CITY OF CARMEL-BY-THE-SEA PLANNING COMMISSION

REGULAR MEETING Wednesday, June 14, 2023

CITY OF CARMEL-BY-THE-SEA PLANNING COMMISSION Staff Report

2 STREET ELEVATION - PROPOSED
1/4" = 1'-0"

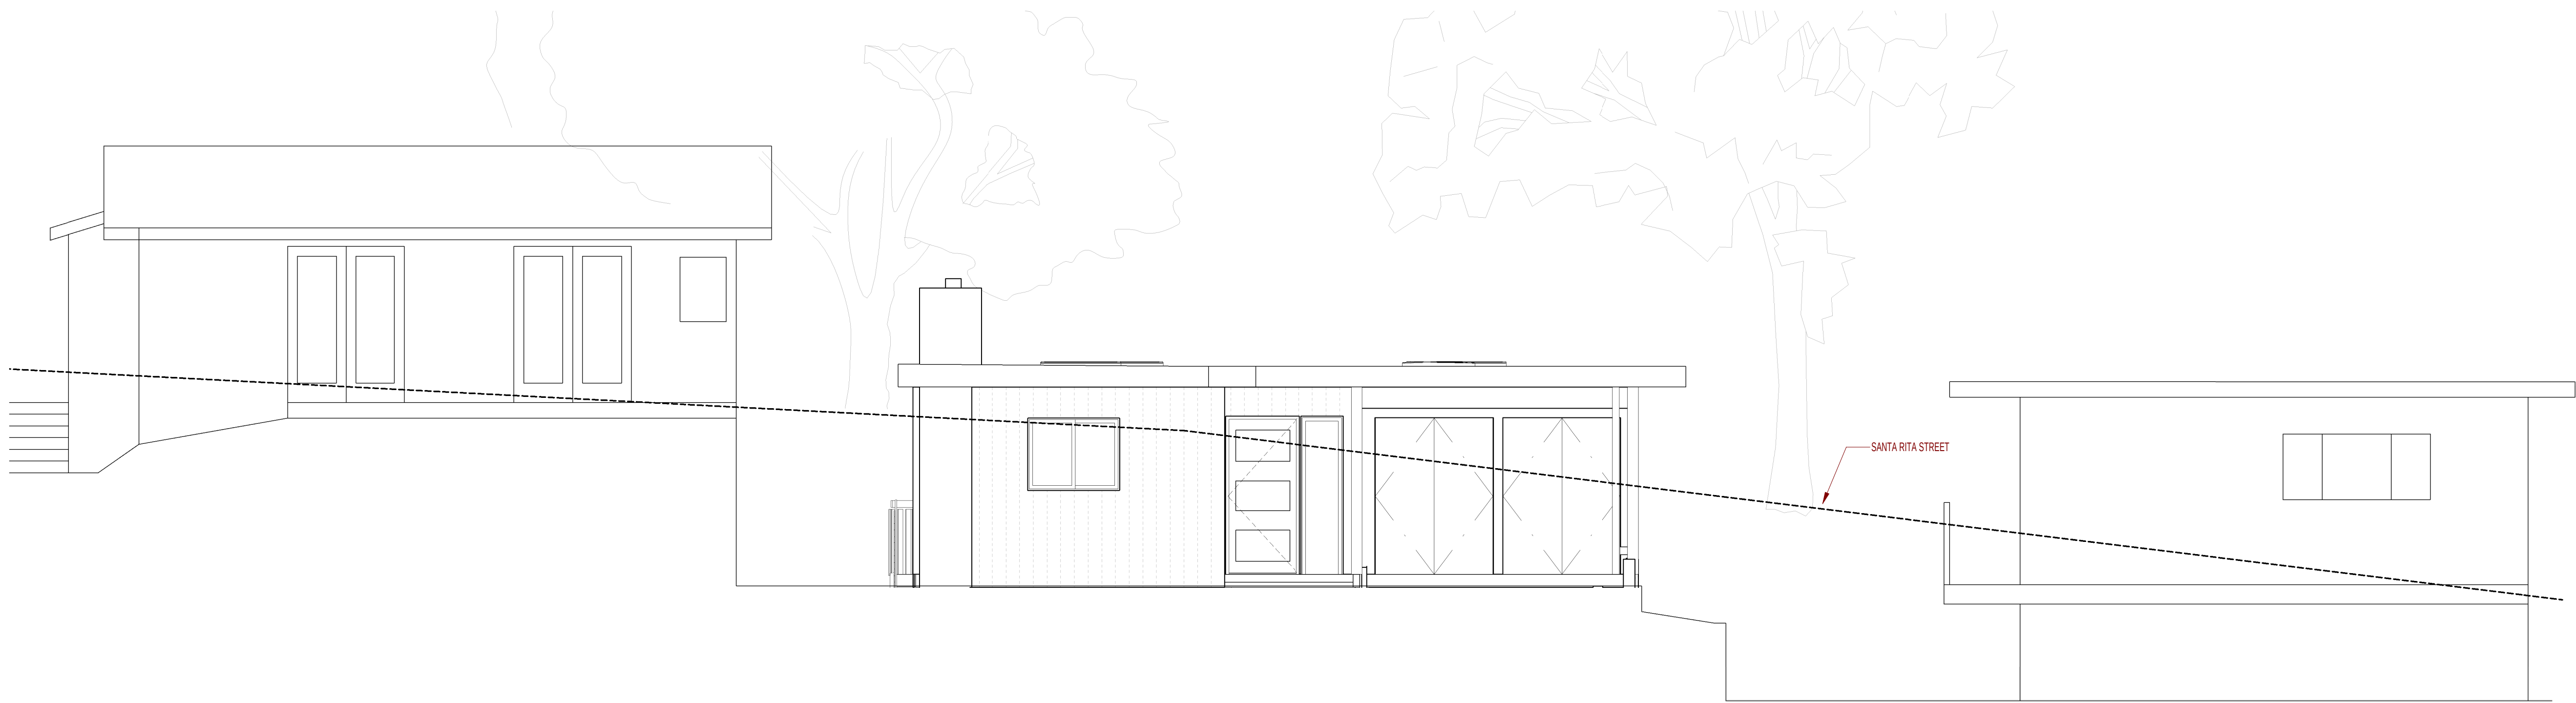
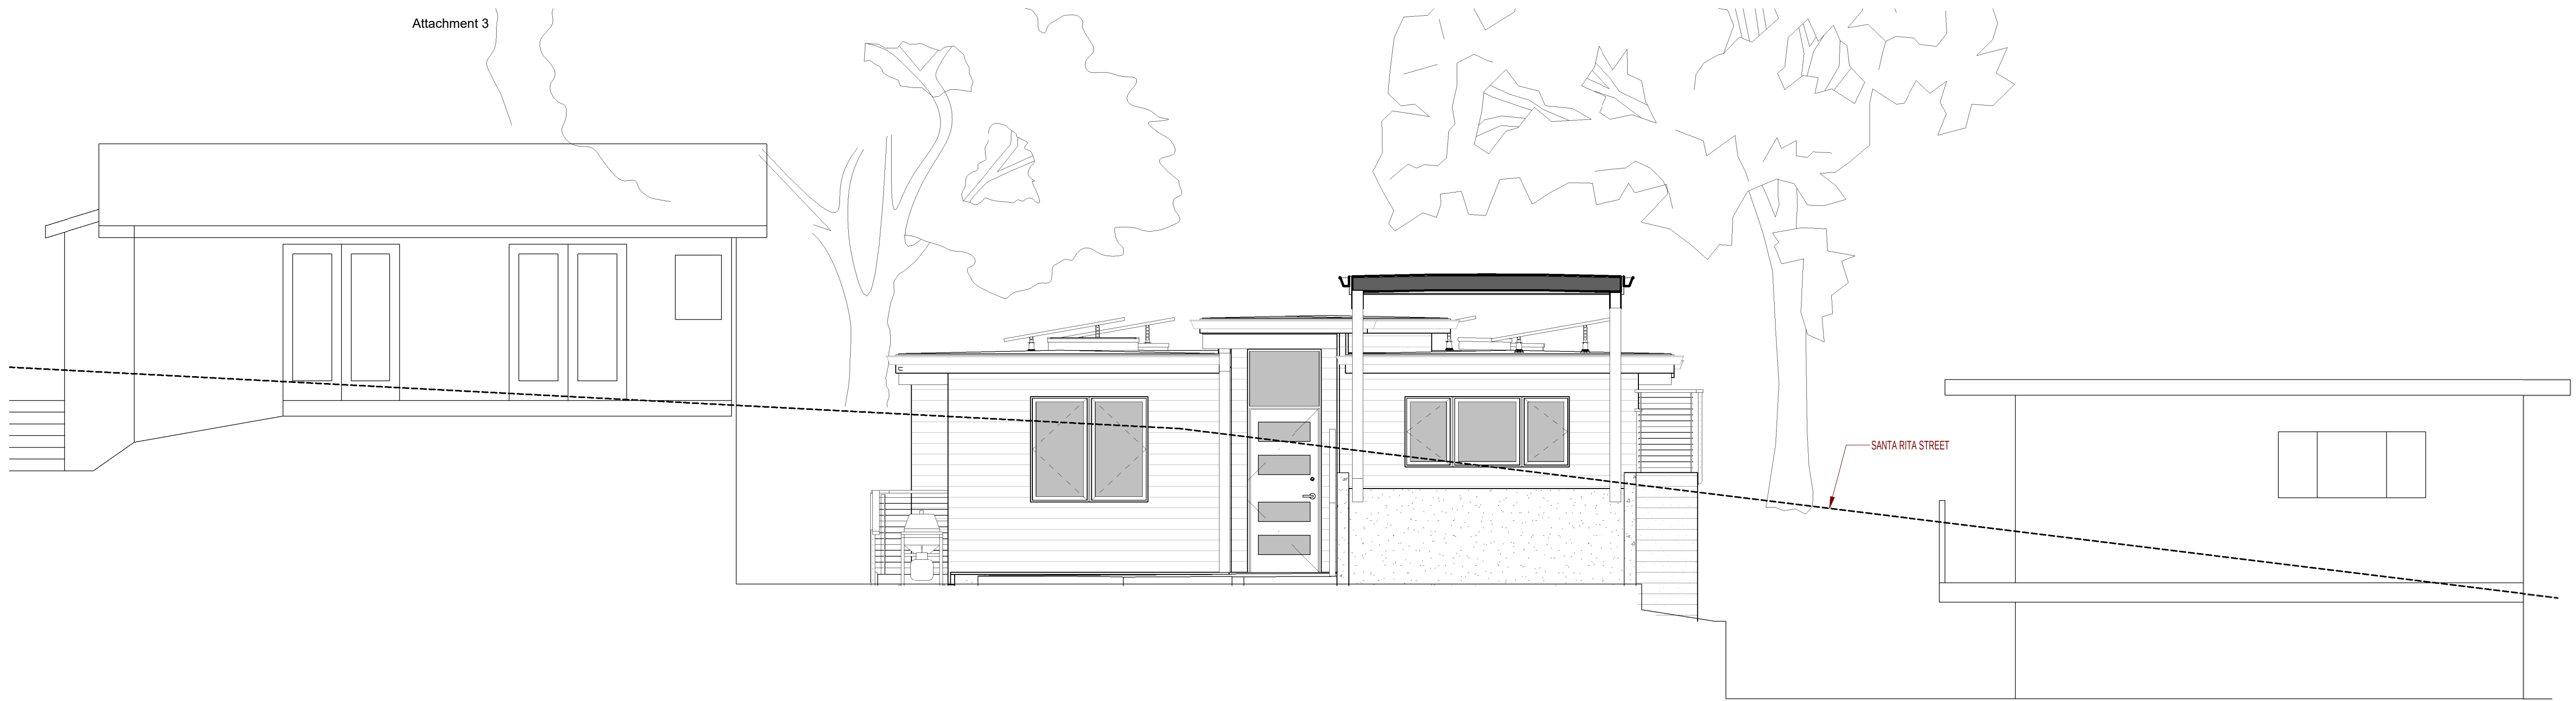
Staff Response: The residence is a nonconforming 2-story house but presents a single-story form on the front elevation and is compatible with the scale of the adjacent homes (refer to Attachment 3, Sheet A3.23). The proposed addition does not significantly increase the mass and bulk of the main residence as seen from the public way. The proposed 268-square-foot net addition would increase the floor area to 1,794 square feet (1,800 allowed). The applicant is not increasing the nonconforming plate height. The maximum plate height for the new addition would be maintained at 22'-6", however, the ridge height would increase by 5" to 23'-8" (24' allowed).

PROPOSED ROOF
PLAN

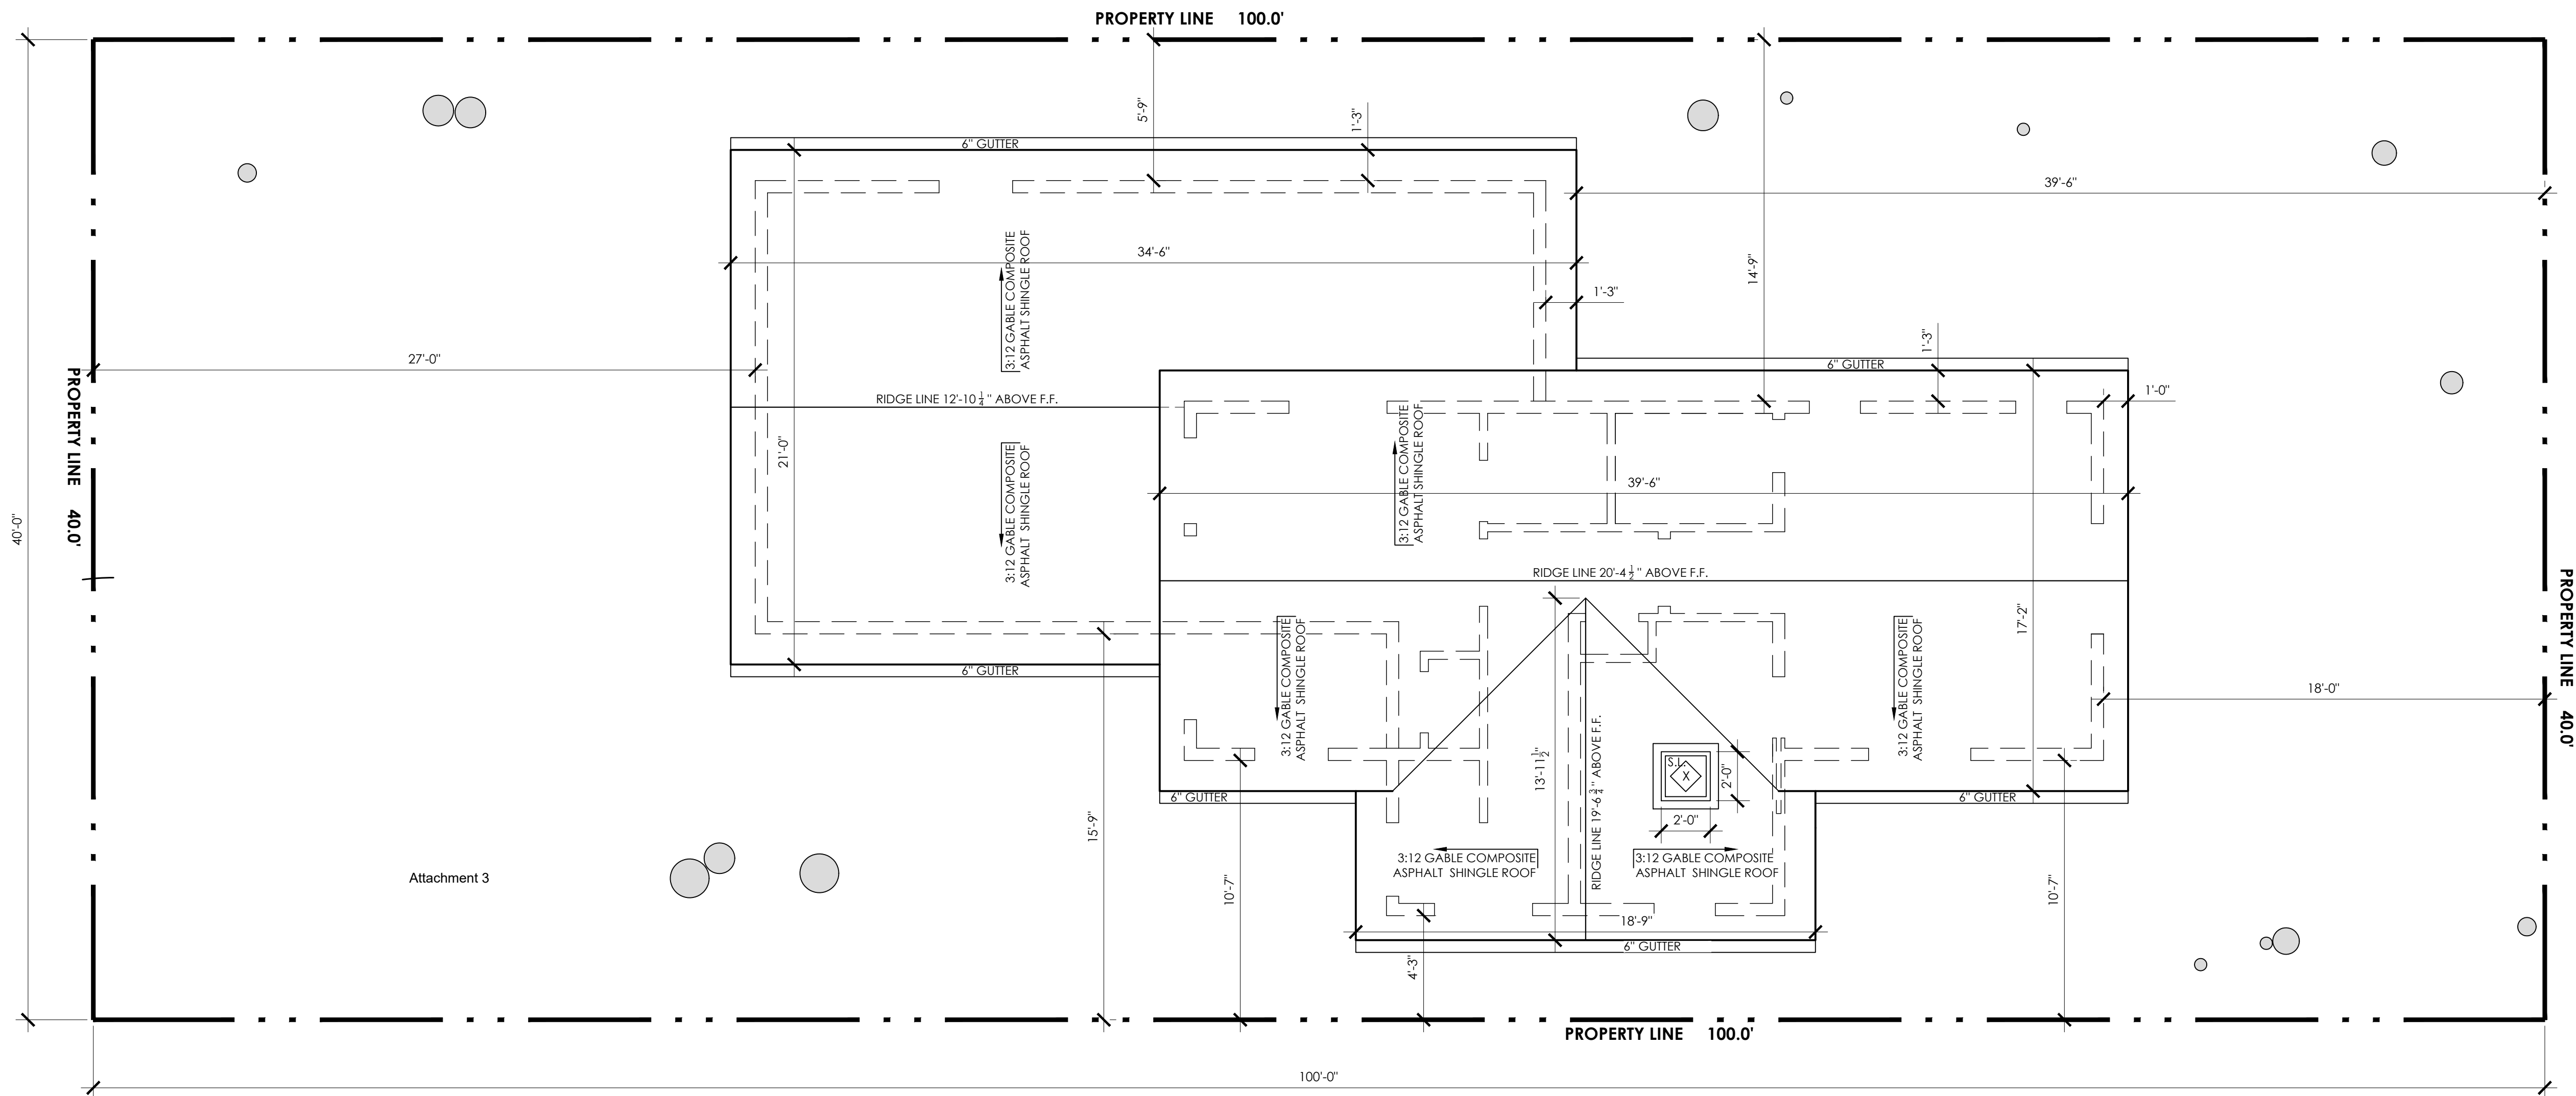
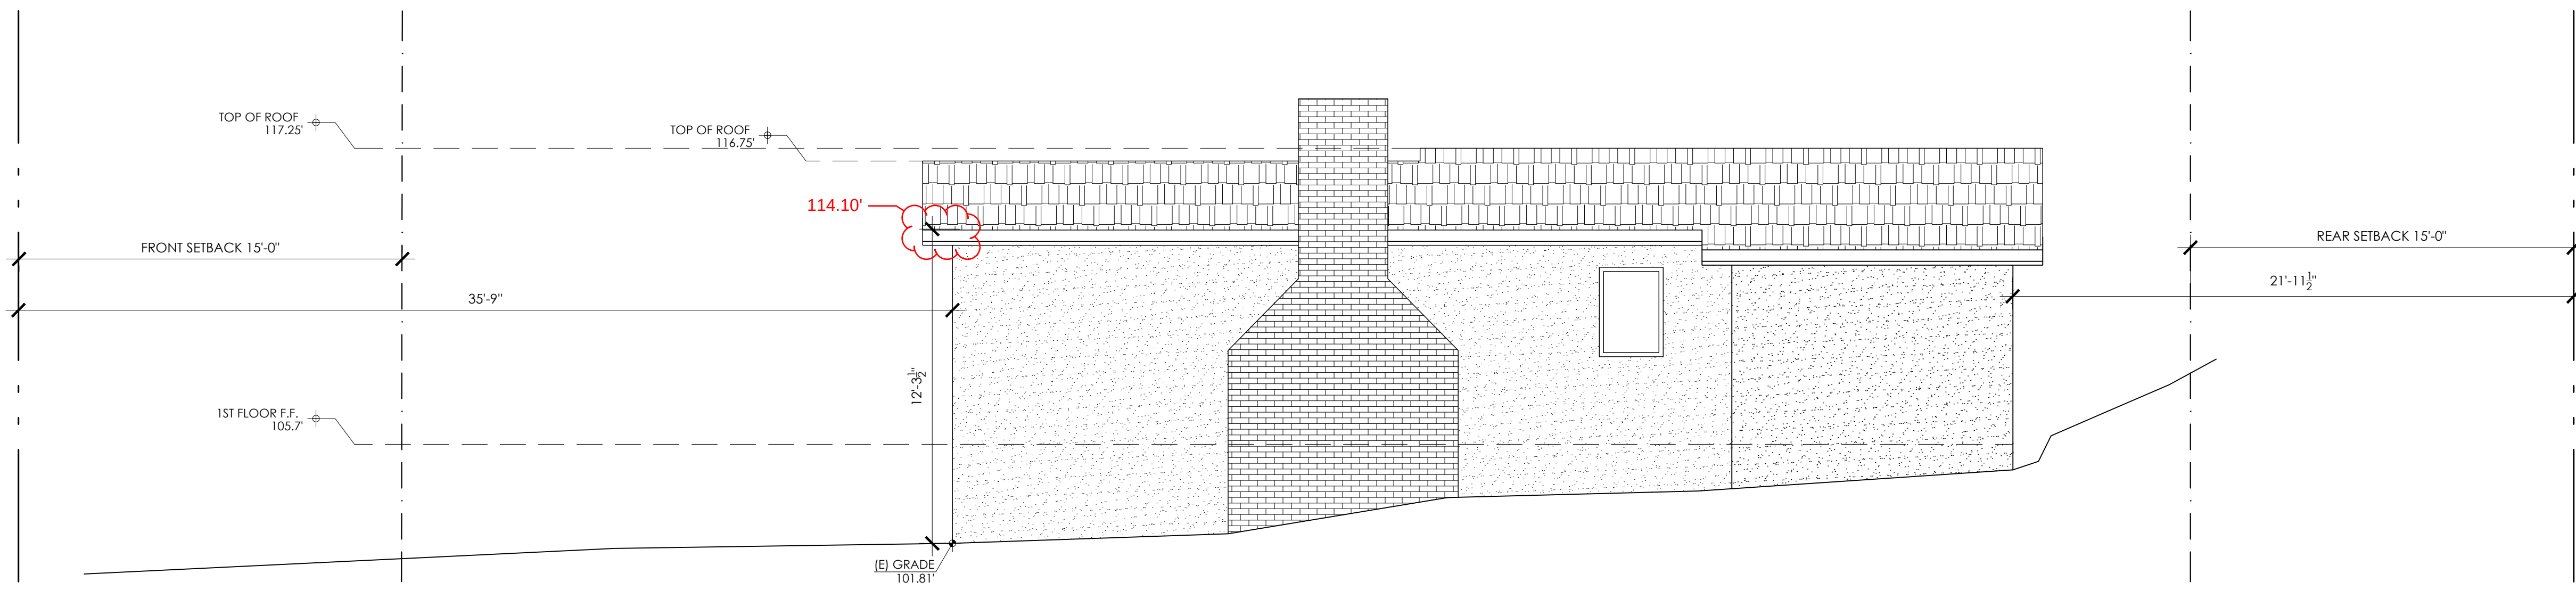
The proposed roof material is listed as cedar wood shake in the Keynotes on Sheets A9 and A10 and on the Proposed Materials on Sheet A13. However, the roof plan on Sheet A7 indicates a composite asphalt shingle roof. The applicant has indicated that the roof material proposed is wood shake. Recommendation/Draft Condition No. 14 requires the applicant to revise Keynotes legend (Sheets A9 and A10), the proposed materials sheet (A13), and the proposed roof plan (Sheet A7) to reflect a consistent roof material prior to the final details review.

14.	Roof Material. Prior to the final details review, the applicant shall revise the Keynotes legend (Sheets A9 and A10), the proposed materials sheet (A13), and the proposed roof plan (Sheet A7) to reflect a consistent roof material.	✓
